Proposal to amend the document ECE/TRANS/WP.29/GRE/2021/2

Modifications to the current proposal text are marked in **red and deleted parts by strikethrough in red.**

Model A
(See paragraph 4.4. of this Regulation)

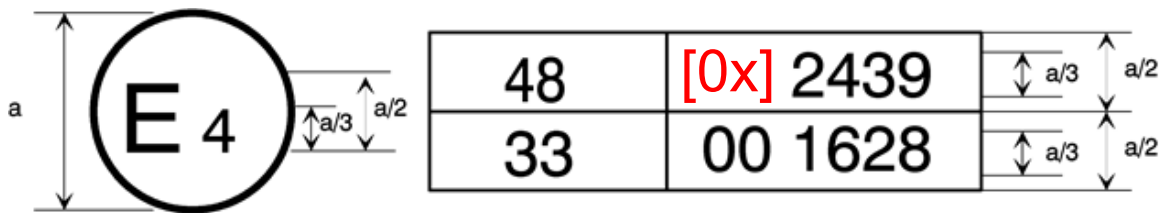
The above approval mark affixed to a vehicle shows that the vehicle type concerned has, with regard to the installation of lighting and light-signalling devices, been approved in the Netherlands (E4) pursuant to UN Regulation No. 48 as amended by the 08[0x] series of amendments. The approval number indicates that the approval was granted in accordance with the requirements of UN Regulation No. 48 as amended by the 08[0x] series of amendments.
